Freeport Desert Road over I-295, Bridge #5720 / Freeport Mallett Drive over I-295, Bridge #5721

ADVISORY COMMITTEE MEETING #4 (virtual meeting)

ADDENDUM TO Freeport Bridge Advisory Committee May 11 Meeting Notes

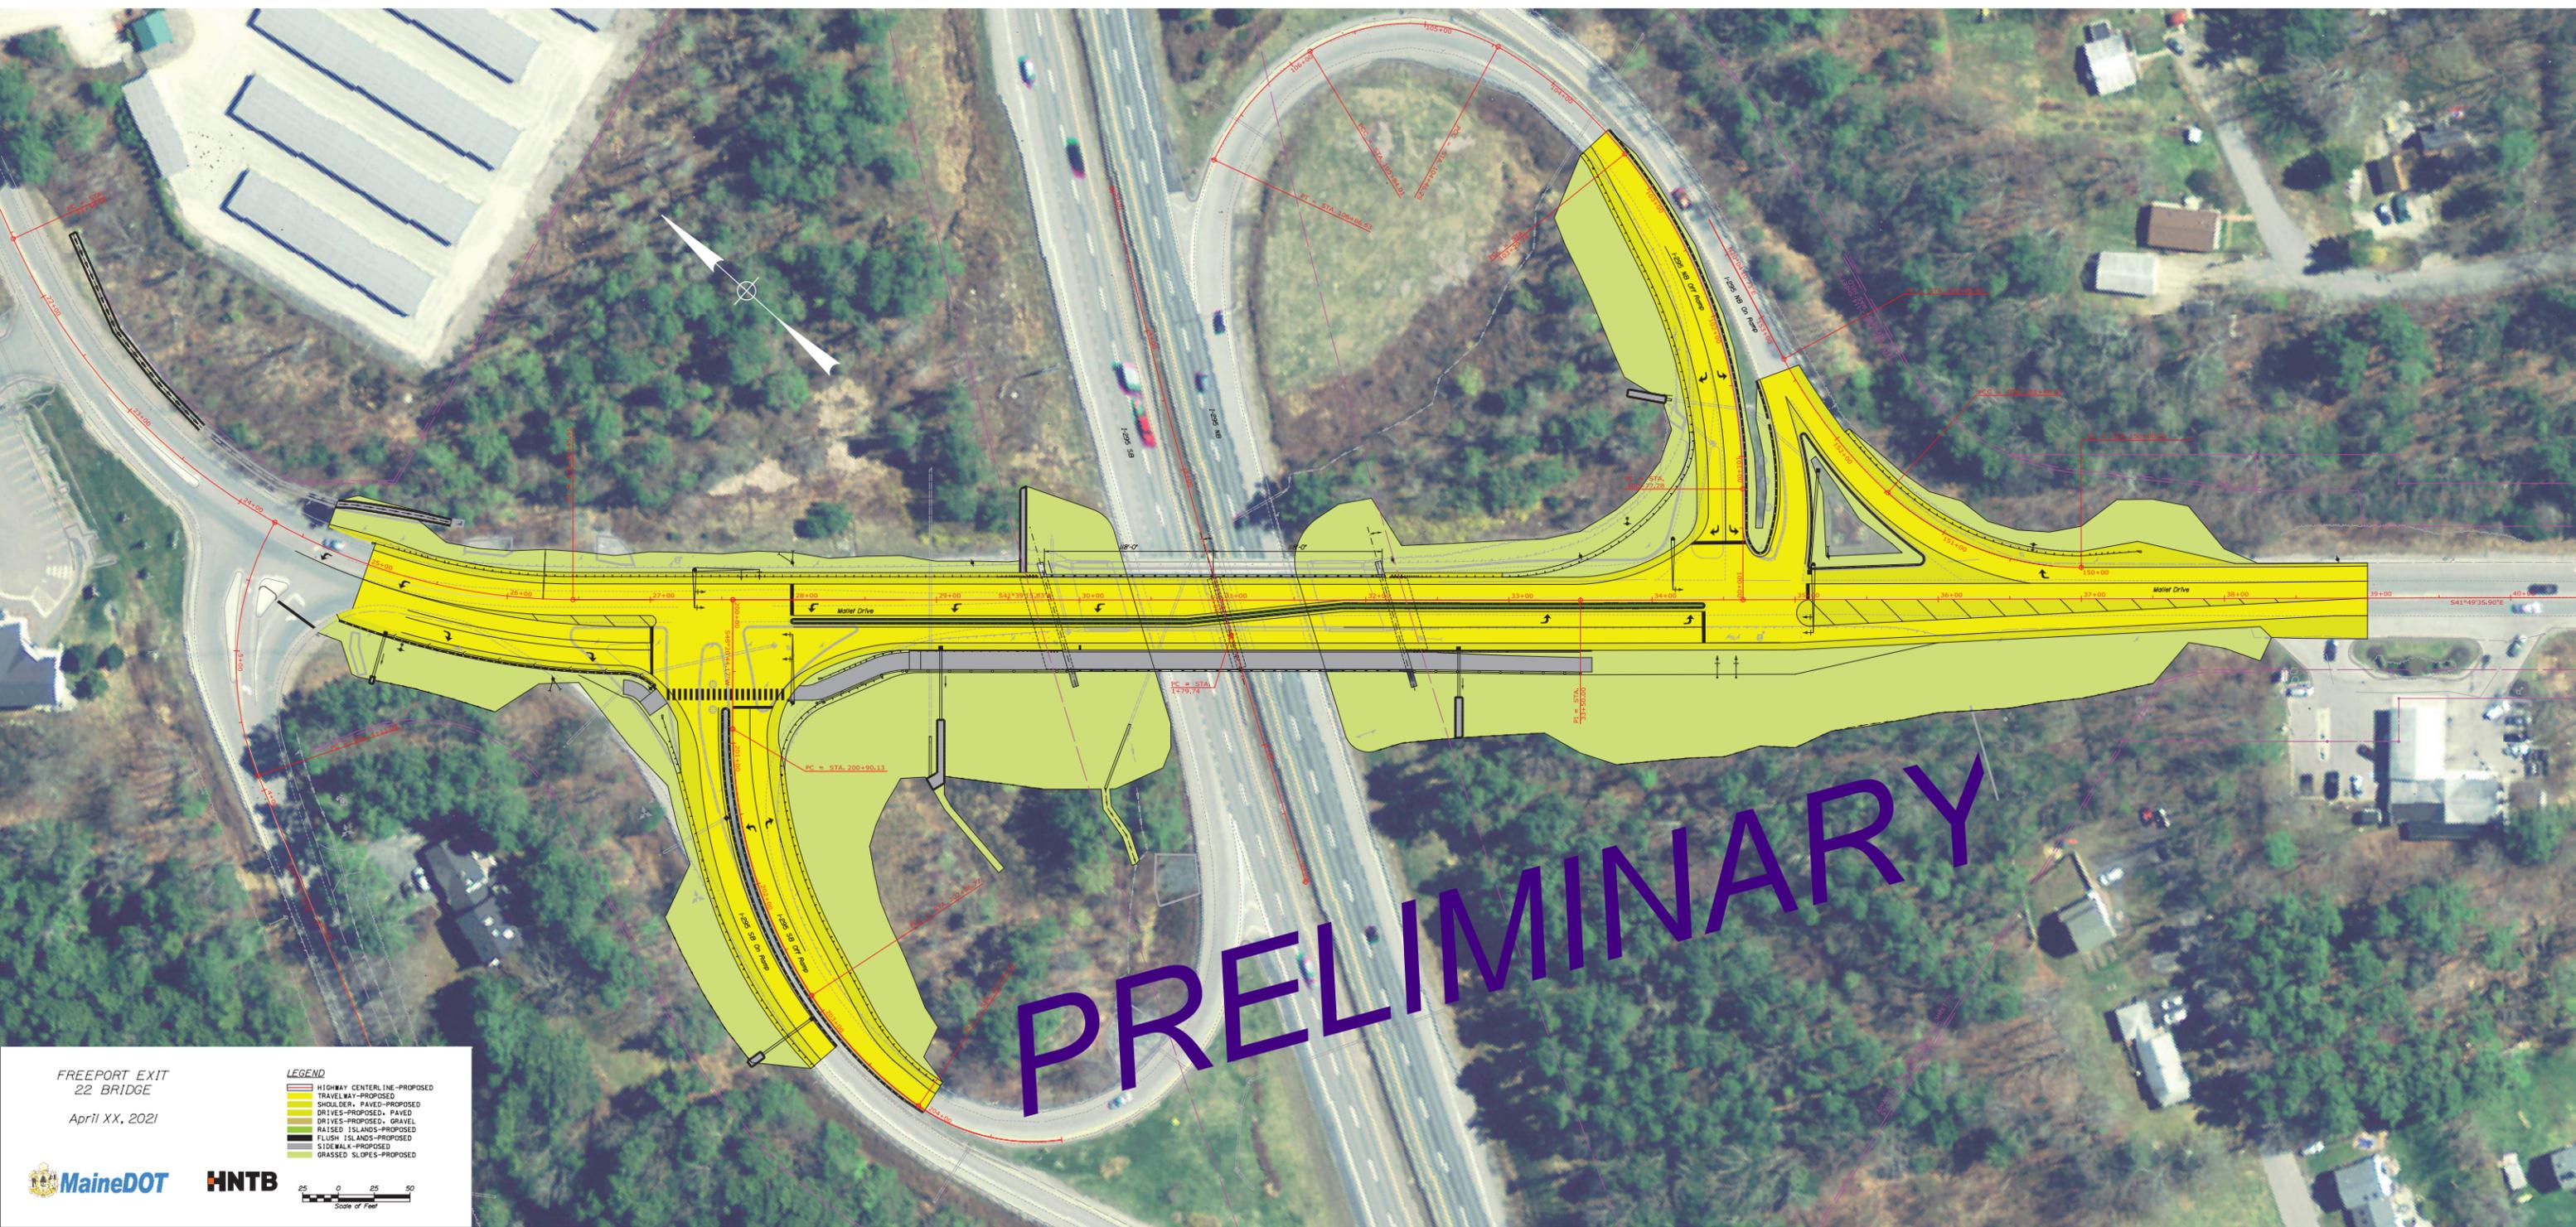
<p>III. Bridge Projects Update</p>	<ul style="list-style-type: none">• Update on recent conversations with Maine DOT.• Presentation by Mr. Bliss of the current (preliminary) design of the Exit 20 and 22 Bridges.• Upcoming meeting scheduled with the Maine DOT on May 11, 2021. This meeting will provide the Bridge Committee members to ask questions and express any concerns they may have.• The discussion focused on the multi-use path transition into and out of the bridge crossings. The path is truncated near the Pownal Road intersection and near the new northbound I-295 ramp signal due to time constraints for right-of-way acquisition from private property owners. The acquisition process can take approximately one year, which is well beyond the September 2021 bid advertisement deadline. The Bridge projects must be advertised because of federal grant requirements.• The transition into and out of the bridge crossings consists of an esplanade adjacent to the travel lane to meet the clear zone standards.• The I-295 northbound ramp entrance at Mallett Drive is shown as a right-turn slip lane which is the current condition.• Road centerline, path alignments, and clear zones are critical design elements that must satisfy the Maine DOT specifications.• The majority of the presentation focused on the Mallett Drive Bridge.• There was less concern with the Desert Road Bridge though traffic signal interconnection and left-turning traffic from Hunter Road were the main concerns.• An onsite meeting will be scheduled to assess traffic at the Mallett Drive-Pownal Road-Route 236 intersection.• A meeting between the ALC and CSC will be scheduled for Monday the 10th to discuss and share their bridge design concerns.• The following questions and concerns were raised by CSC members.<ul style="list-style-type: none">○ Does the tapered path (the wedge near Irving) need to be grass or can it be crushed stone?○ Can a retaining wall be constructed instead of going through the right-of-way acquisition process?○ Will cost-sharing be reduced since the path is proposed to be shortened?○ What can be done to make the right-hand slip lane onto I-295 northbound safer if the intersection cannot be T-ed up like the southbound ramp is proposed?	<p>Informational only, no vote.</p>

<ul style="list-style-type: none">○ What does the accident and crash data indicate for the Mallett Drive area?○ How will pedestrians safely cross Mallett Drive from the north to the south side where the multi-use path will be located?○ Will the crossing of Mallett Drive occur midway between the bridge and Main Street, or will it happen at a controlled location such as the I-295 northbound signal or at a crosswalk with a flashing beacon before the right-hand slip lane?○ There are two main considerations with the Mallett Drive Bridge: (1) safety and (2) traffic back-up at the I-295 southbound ramp signal.○ How will vehicles be able to get out of the Freeport Medical Center and Pownal Road intersection?○ The current design has traffic congestion and accident implications.○ How are pedestrian safety needs and vehicle movements balanced for this project?○ Concern was raised for traffic stoppage at the signals due to signal wait times for up to a minute.○ Ramp crosswalks will have a push-button for pedestrians to activate the crosswalk signal.○ The CSC and Bridge Committee members should be clear and unified on their objectives. Solutions should be present to the Maine DOT.○ Does it make sense to include a center turn lane within Mallett Drive to allow for traffic turning into and out of businesses?○ Will the intersection at Hunter Road and Desert Road be improved for left-turning traffic onto Desert Road headed east to Lower Main Street?

FREEPORT EXIT
22 BRIDGE

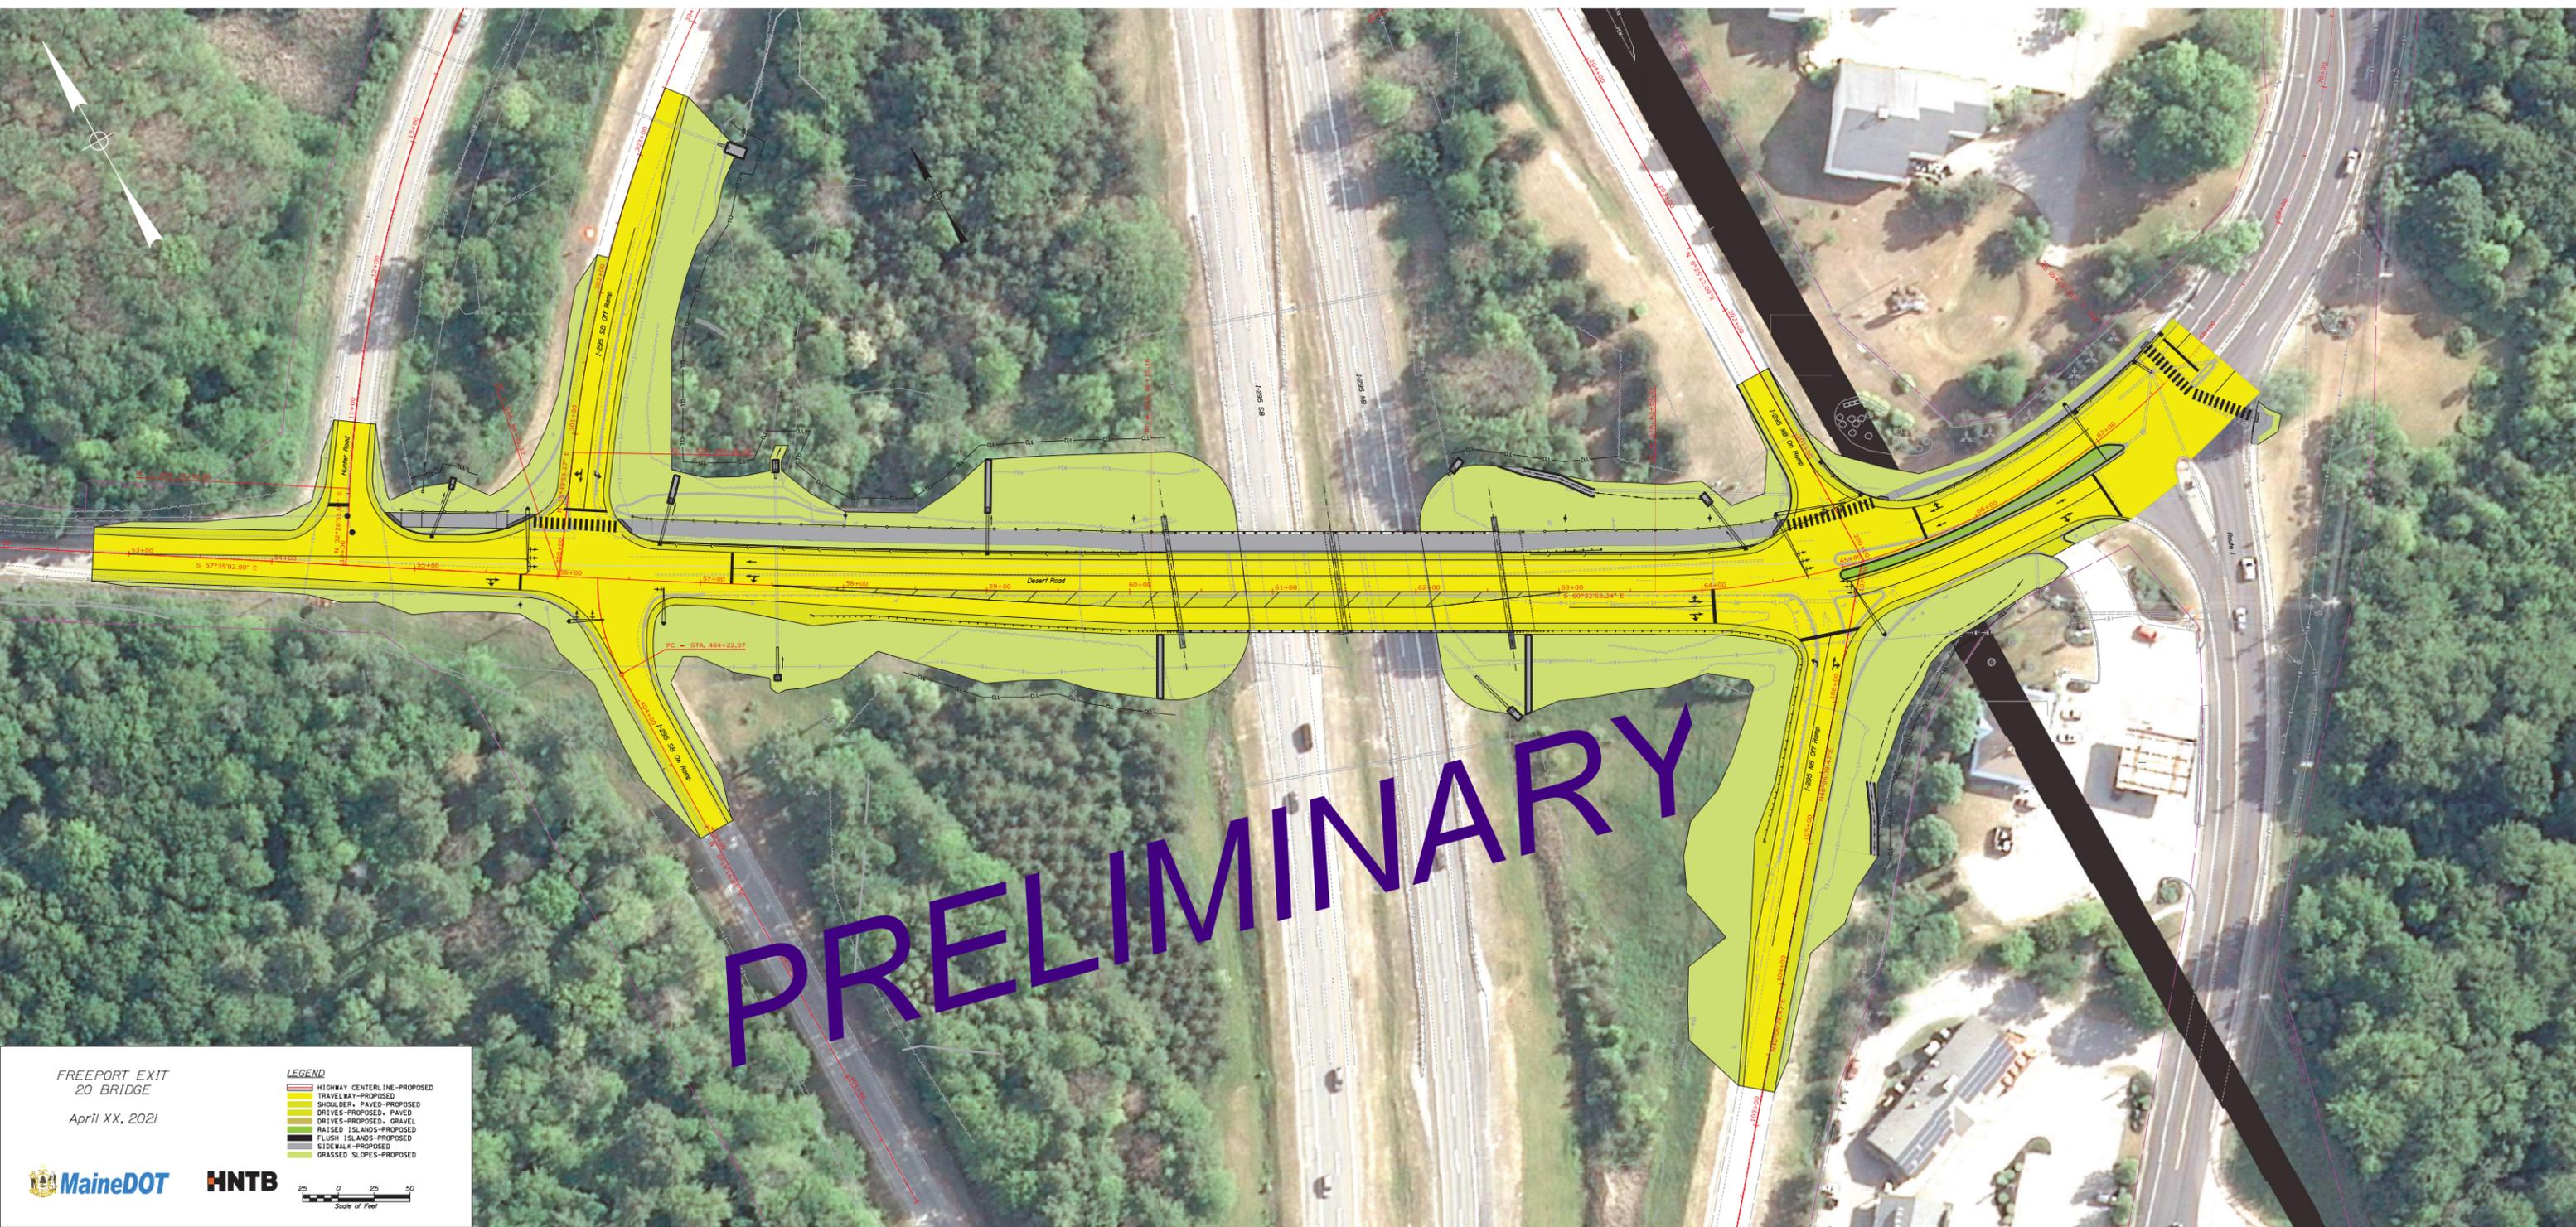
1. Can the multi-use pathway be extended to the light on the East side of the bridge? *Response: This will be reviewed.*
2. Why is the pathway tapered on the East side of the bridge on the South side? *Response: The path edge must shift away from the roadway where guardrail is terminated so that the nearest edge of path is located 10' from the nearest travel lane. Also, the width of the paved path is show at 10' compared to 12' at the bridge. The paved width will be revised to 12'.*

3. In the transition from concrete barrier to the steel guard rail, how does that impact the shoulder width and path widths? *Response: The preliminary plans show the path pavement extending under the steel guardrail to the face of roadway curb at this location. Alternatively, a grass panel could be considered with a reduced pavement width along the path to provide a shoulder/buffer like that along the pedestrian fencing. It is difficult to maintain a narrow grass strip under guardrail, so pavement is often extended underneath it to reduce future maintenance. The shoulder width of the*

4. We would like to better understand the I-295N sliplane's re-entry into the design *Response: The Department and the design team will provide more information regarding the NB on/off intersection configuration.*
5. We would like to better understand the design change of the multi-use path on the West side. What issues prevent a continuance of the path to Pownal Road as previously designed? *Response: The project design limits required for the bridge replacement tie-in before Pownal Road which is different than originally anticipated. Previous graphics were developed prior to completing preliminary design. A curb is provided between Pownal Road and the SB on ramp to accommodate a future path connection at this location.*
